# Aftersales Field Action Bulletin

Document ID: 8-23-GL-00-003

Bulletin Title: Battery Chiller O-ring replacement & AC Compressor oil addition

**Leakage confirmed with Sniffer and Air bubble**

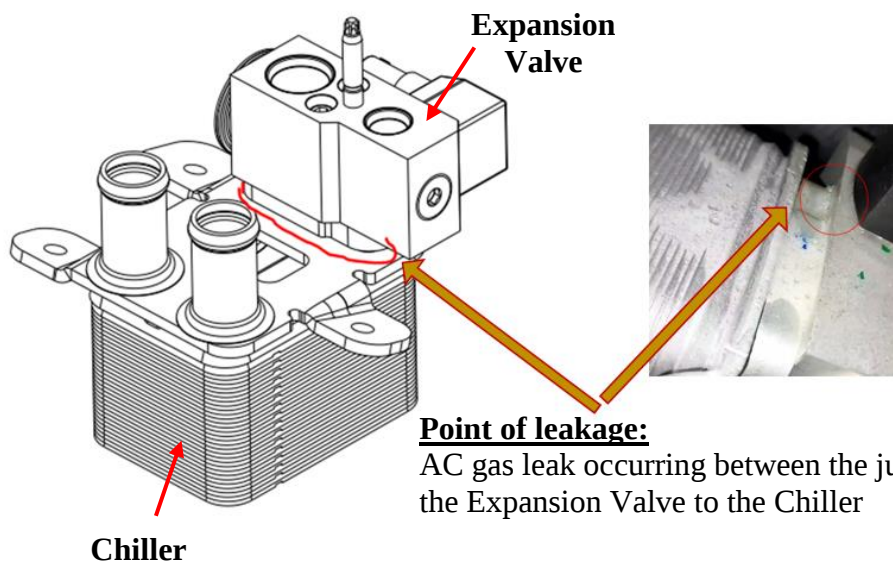
Air conditioning system lost its cooling function inside the passenger compartment due to refrigerant leak in the CHILLER zone.

The internal component O-ring sealing between the Expansion valve & Chiller is poor, which is the probable root cause for the Refrigerant leak.

**Leakage position in vehicle view - Batt Chiller**

#### **Point of leakage:**

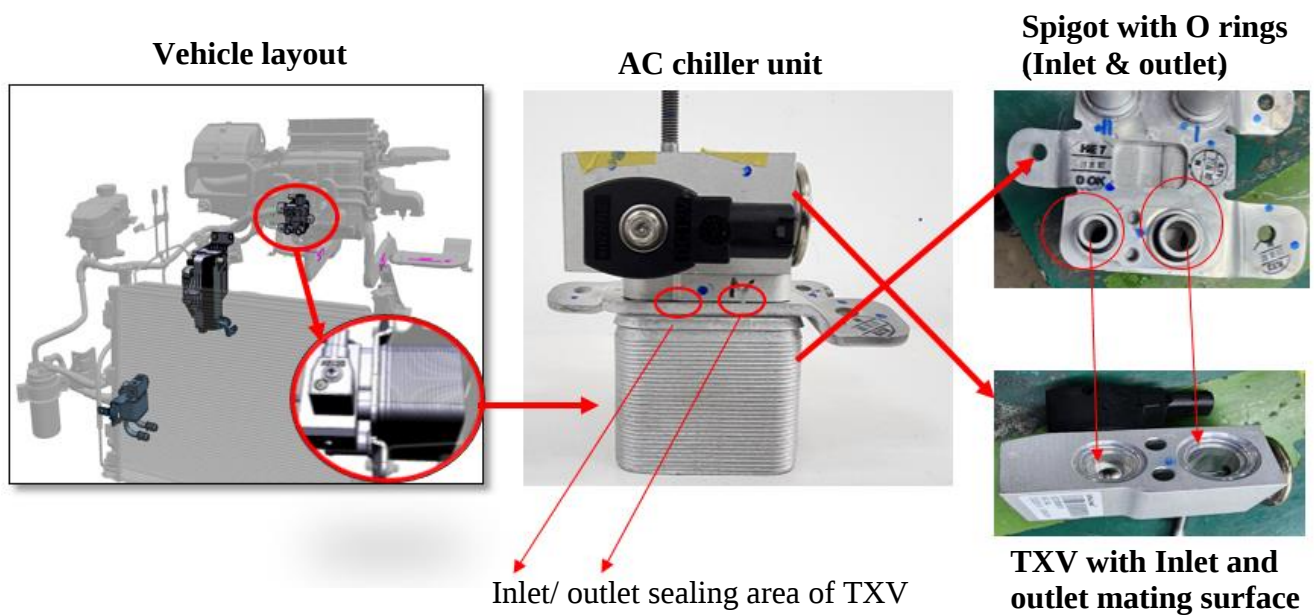
AC gas leak occurring between the junctions of the Expansion Valve to the Chiller

### Root Cause:

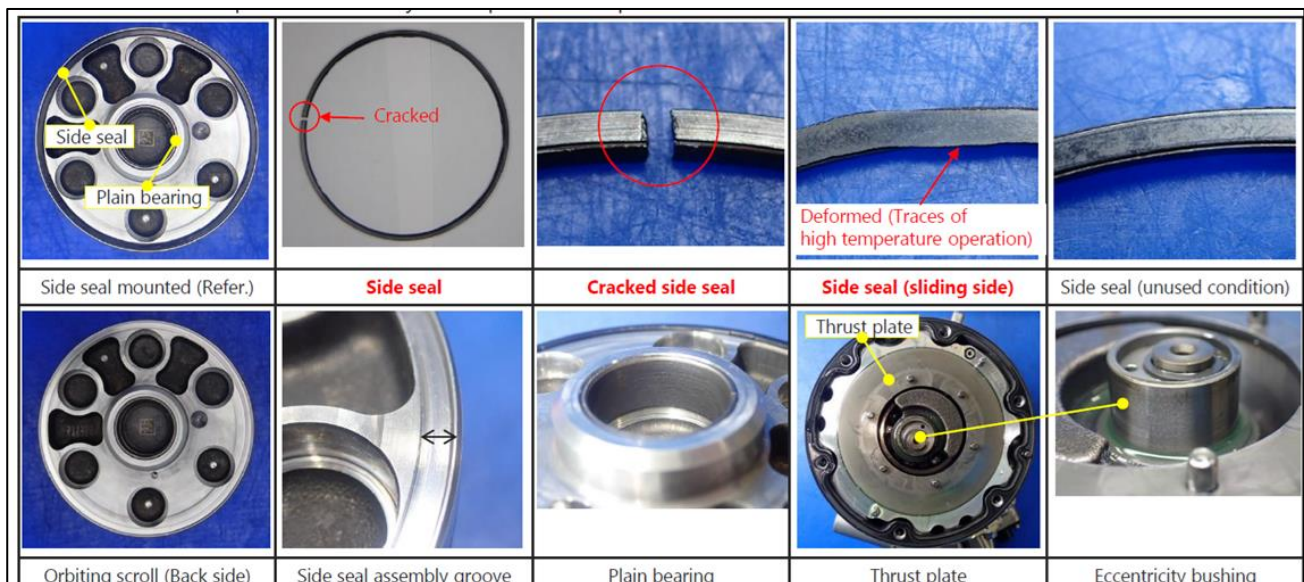
Refrigerant system compressor oil [PAG ISO 46] capacity of **120ml +/-15ml** in the vehicle is not sufficient to maintain the temperature & pressure. Therefore, after starting the vehicle, the discharge pressure raises immediately and compressor stopped by overheat.

1. Low refrigerant flow rate & poor cooling for IGBT due to circuit block.
2. Temperature rise on all sliding parts which leads to decreased strength in side seal and gets cracked.

To **add 100ml of oil** to the AC compressor in additional to 120 ml of oil, which is already presented in the compressor [Total fluid capacity in compressor: 120 ml (existing) + 100 ml (add) = 220 ml].
